工程指示 / 要求簡箋 ENGINEER INSTRUCTIONS (E.I.)

| 工程指示編號: | EI- 4790D | 修改版本: | D |
| 工程編號: | J 853 | 工程名稱: | 大窩坪 (延坪道) |
| 工程項目: | T3 幕牆單元件生產 (大貨) (修訂D:修改Z字碼設計及修改分格呎吋) | 日期: | 29/07/2022 |

| 名稱 | 生邊企 | 制圖 | 付吉寧 | 2022.05.20 | 修改 | A | B |

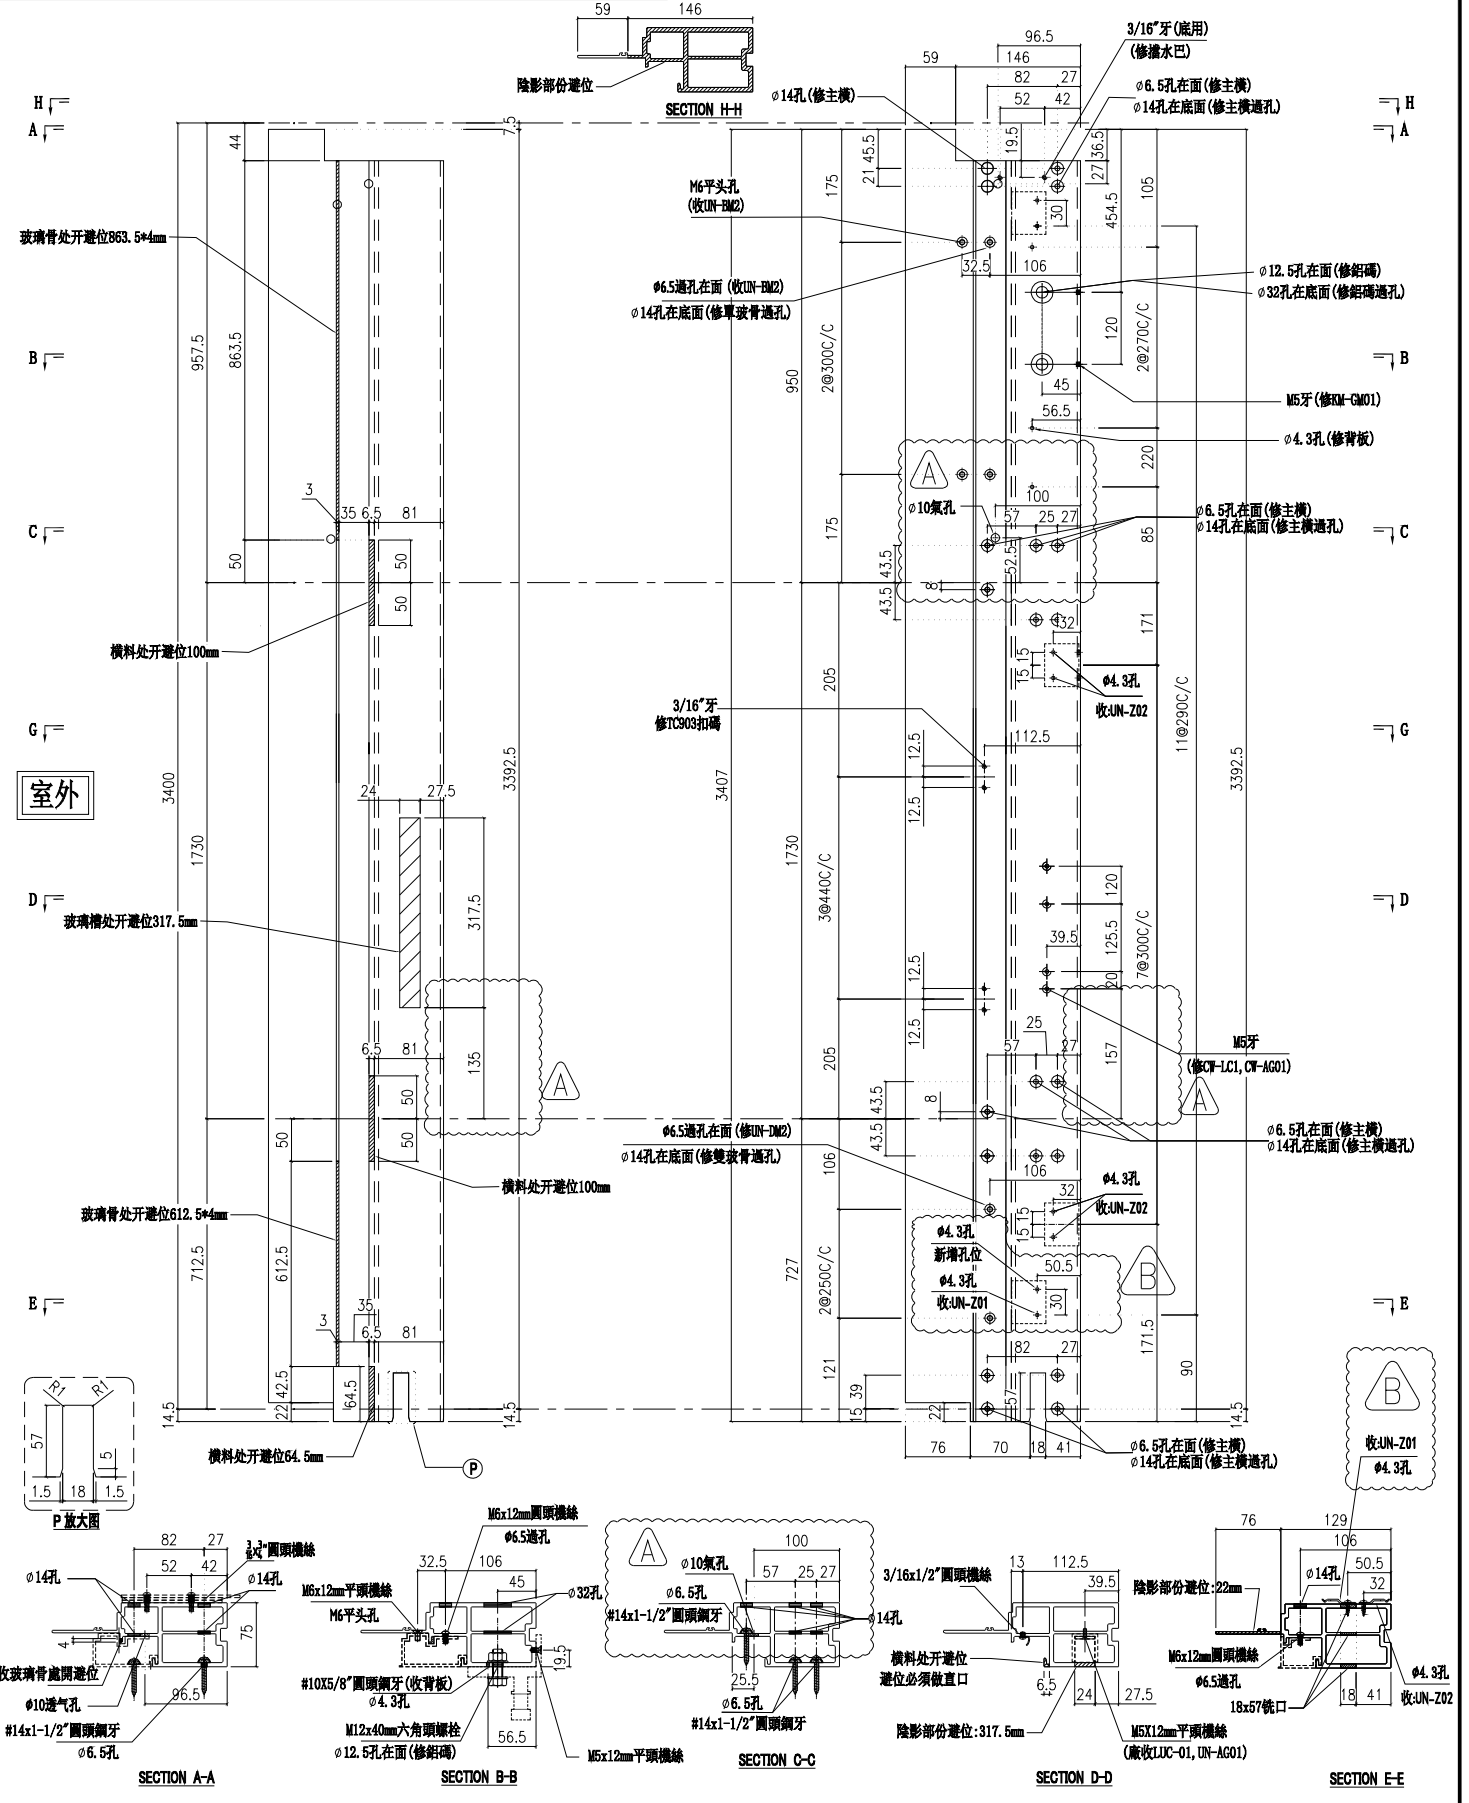
依據E14825, 修改欄河槽及孔位尺寸
新增 $\phi 10$ 氣孔

依據E14878-B版更換Z字碼及新增Z字碼孔位
原Z字碼編號: UN-Z03-03改為: UN-Z01

| 名稱 | 生邊企 | 制圖 | 付吉寧 | 2022.05.20 | 修改 | A | B |

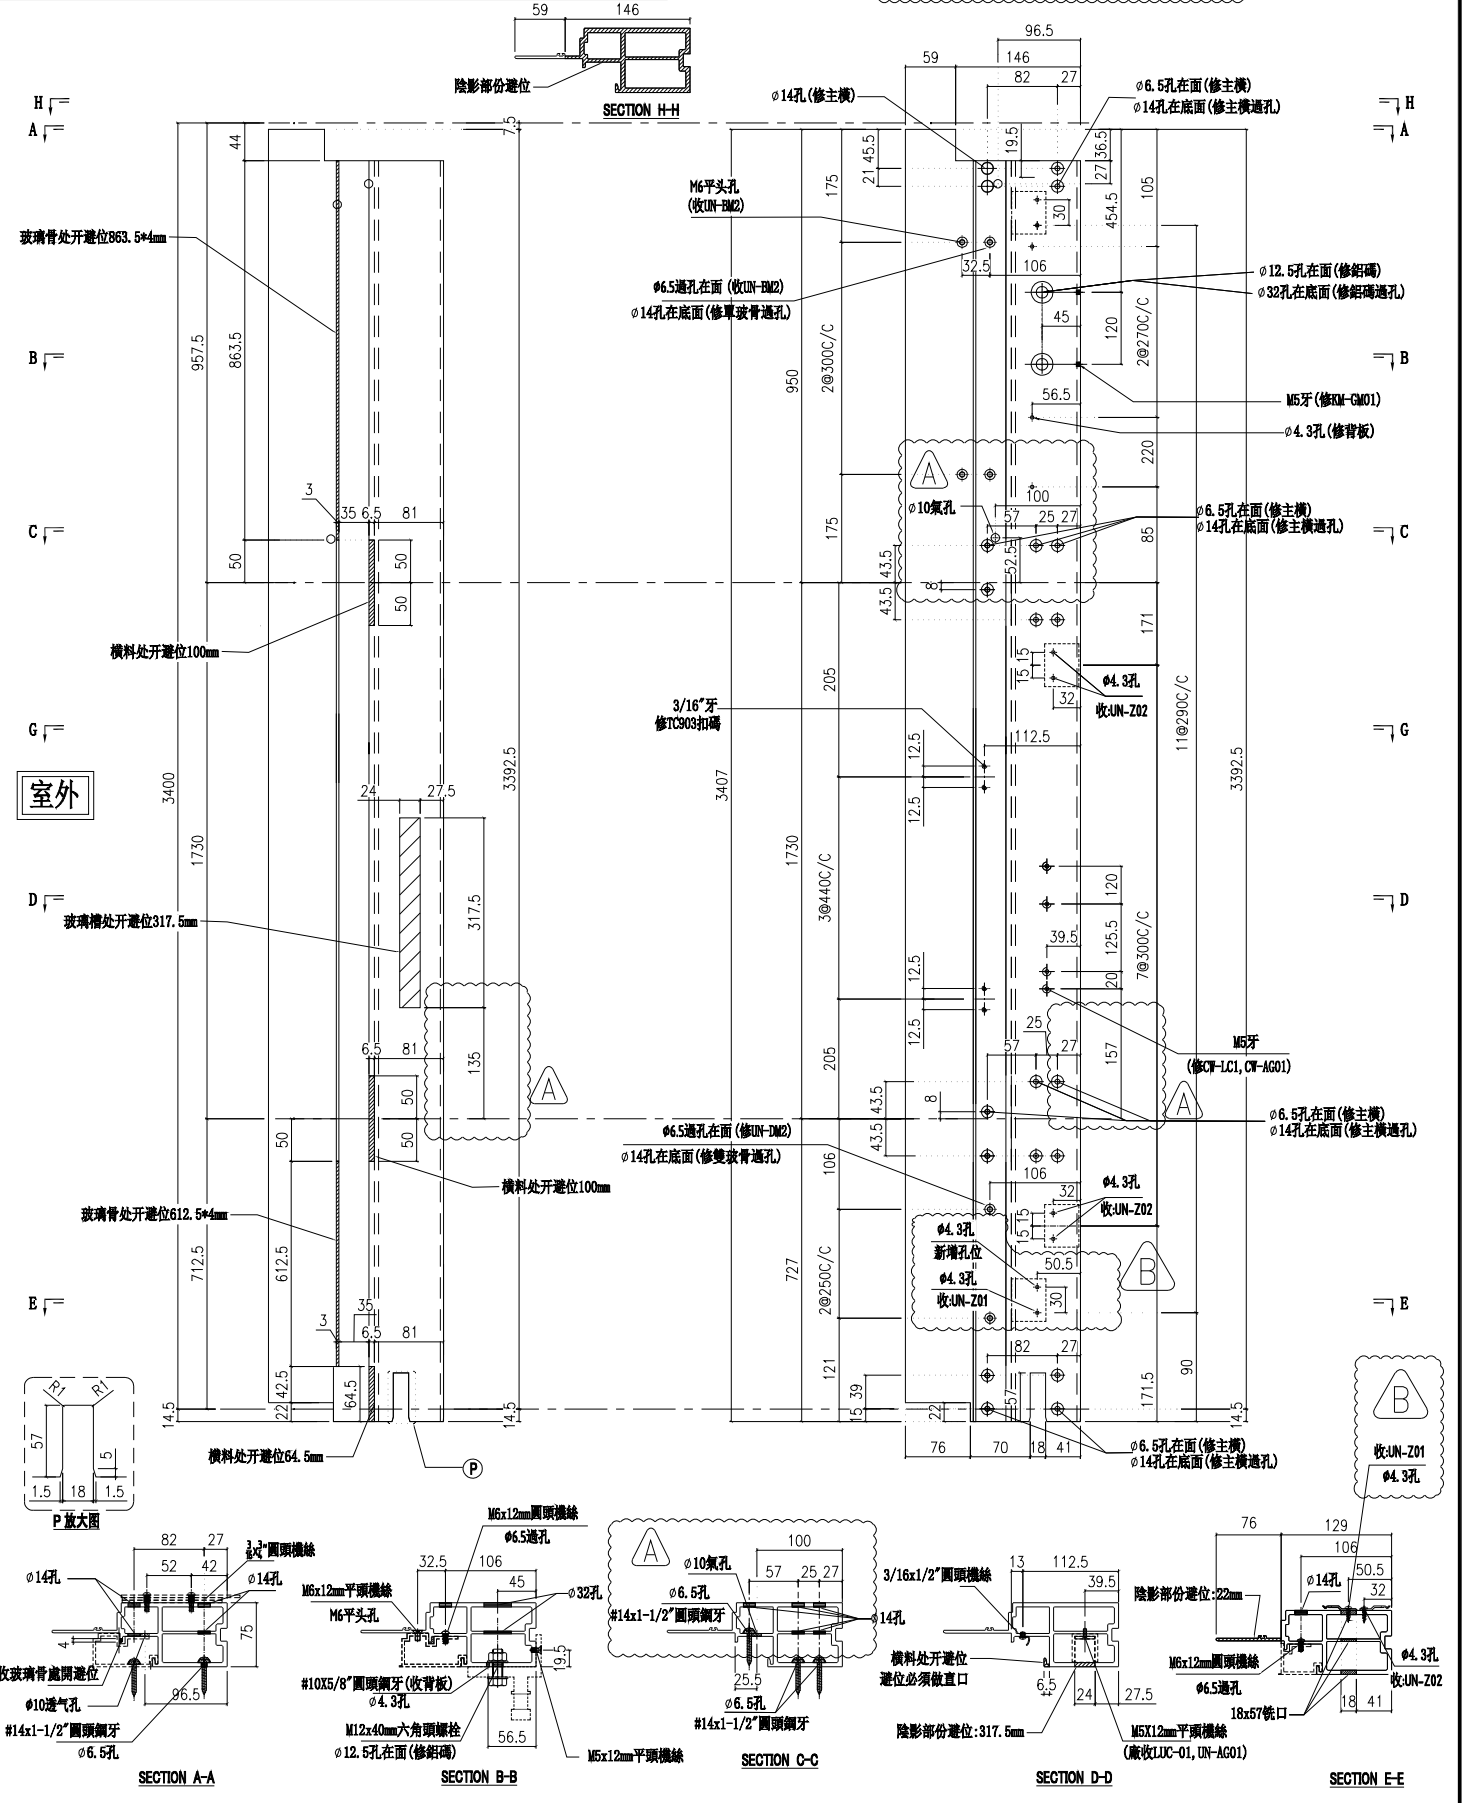
依據E14878-B版更換Z字碼及新增Z字碼孔位
新增10氣孔

原Z字碼編號: UN-Z03-03改為: UN-Z01

| 名稱 | 生邊企 | 制圖 | 付吉寧 | 2022.05.20 | 修改 | A | B |

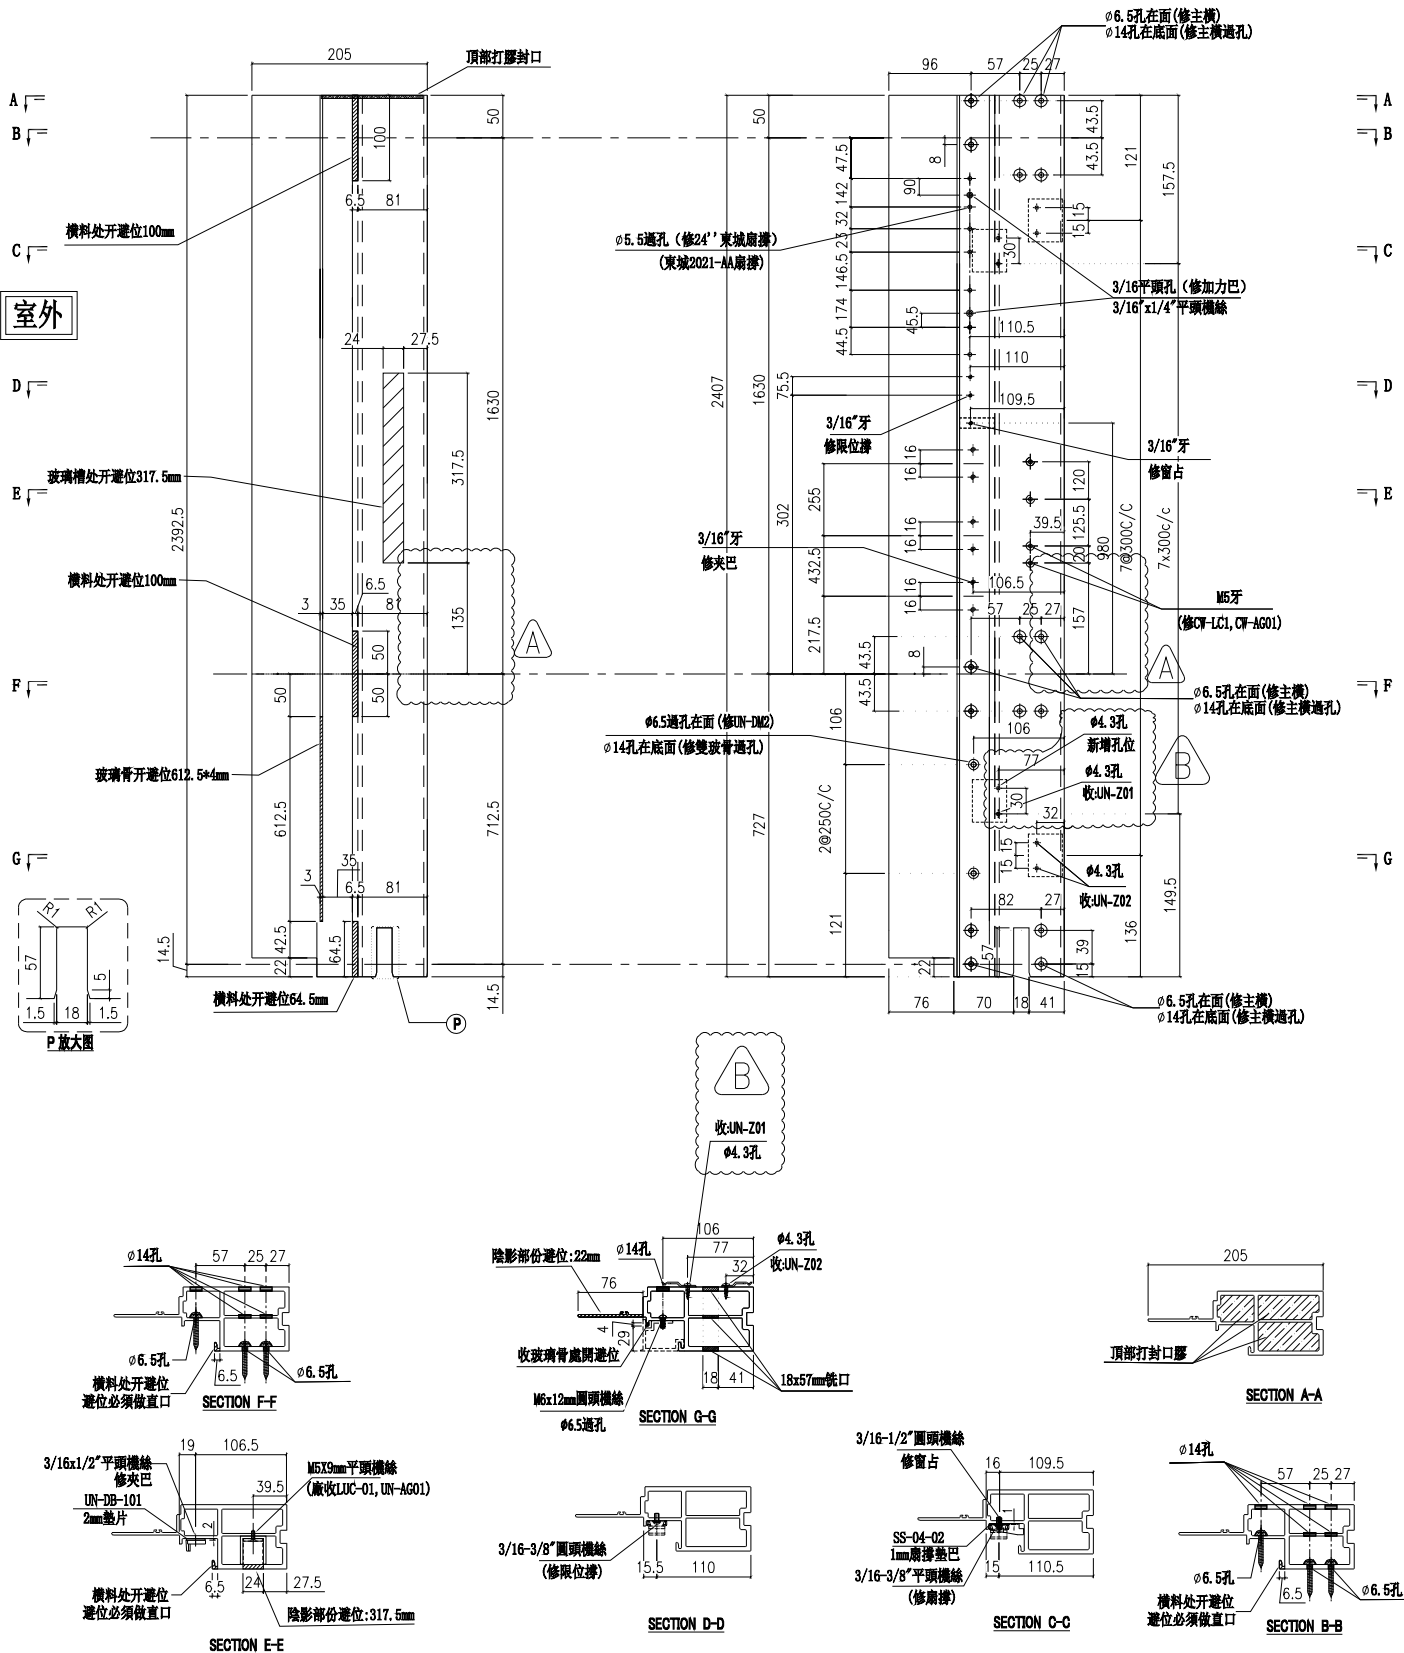
依據EI4825, 修改攔河槽及孔位尺寸

依據EI4878-B版更換Z字碼及新增Z字碼孔位
原Z字碼編號: UN-Z03-02改為: UN-Z01

| 名稱 | 生公企 | 制圖 | 付吉寧 | 2022.05.20 | 修改 | A | B |

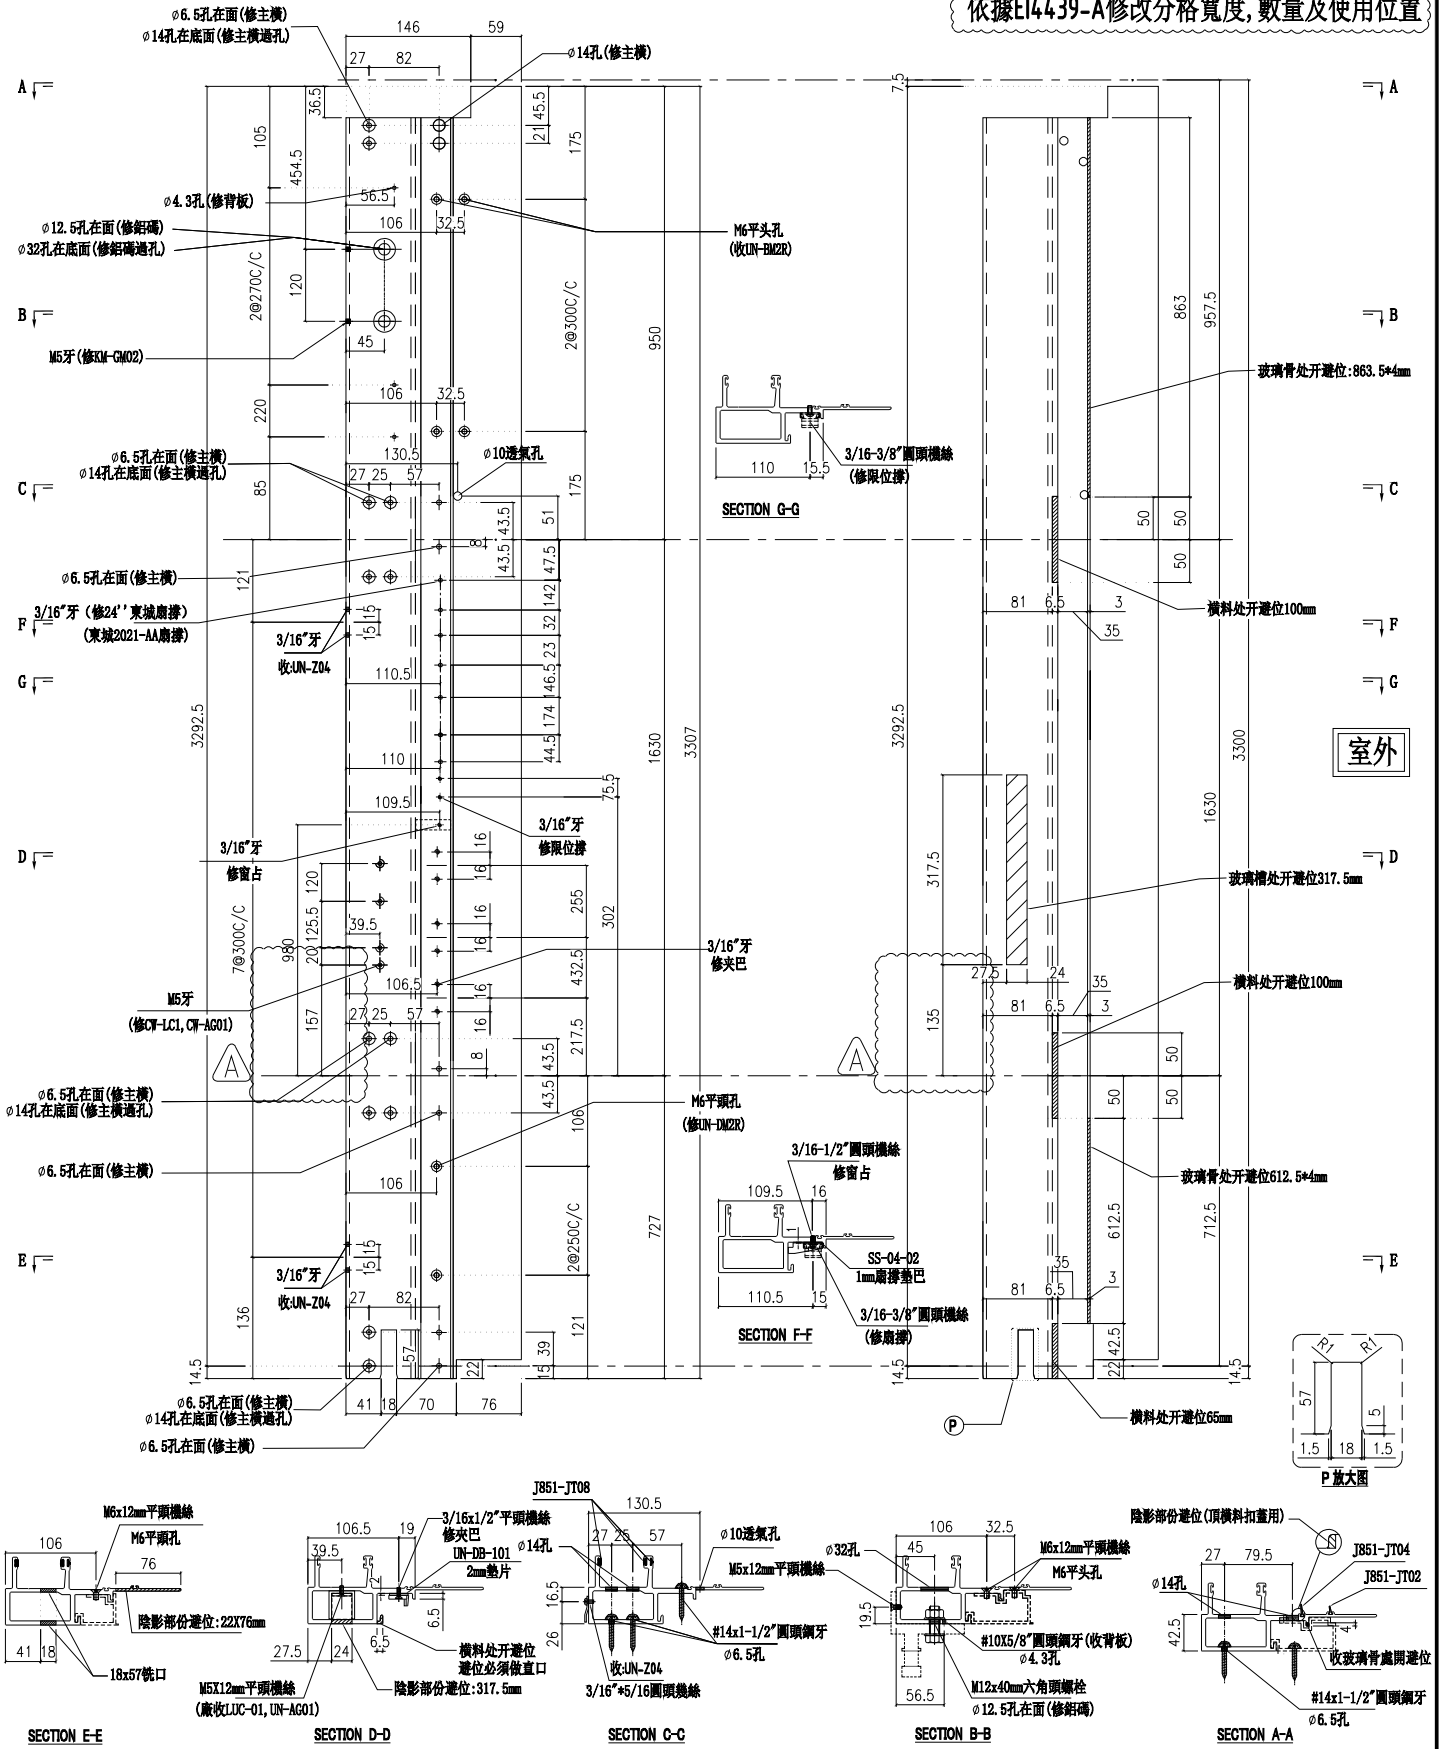
依據EI4825, 修改攔河槽及孔位尺寸

依據EI4439-A修改分格寬度, 數量及使用位置
